RE: **1-ZN-2023 and 1-GP-2023**
6C692 (Key Code) and 98T77 (Keycode)
Pinnacle Peak Doggy Daycare

Planning & Development Services has completed review of the above referenced development application. The following comments represent issues or deficiencies identified by the review team and are intended to provide you with guidance for compliance with city codes, policies, and guidelines.

PARKING CALCULATIONS

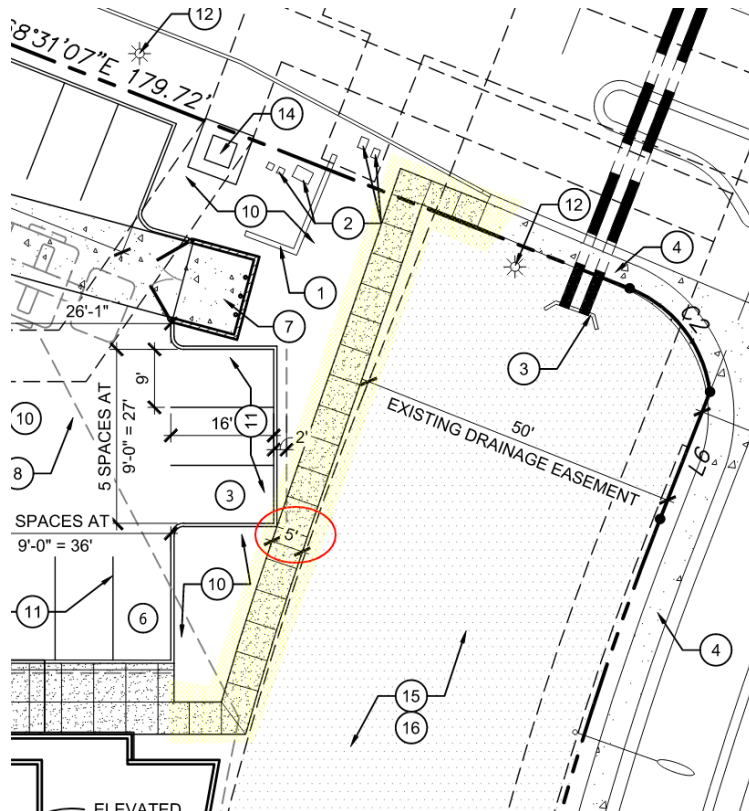
12. Please confirm there will be no outdoor kennels (just outdoor play area) on site. The building area and parking calculations list a kennel sf. All kennel sf must be indoor and accounted for parking wise. This may just be a left over "kennel" label from first review. Please confirm the overall building SF of 9,000 SF accounts for the indoor kennel sf proposed. Thank you.
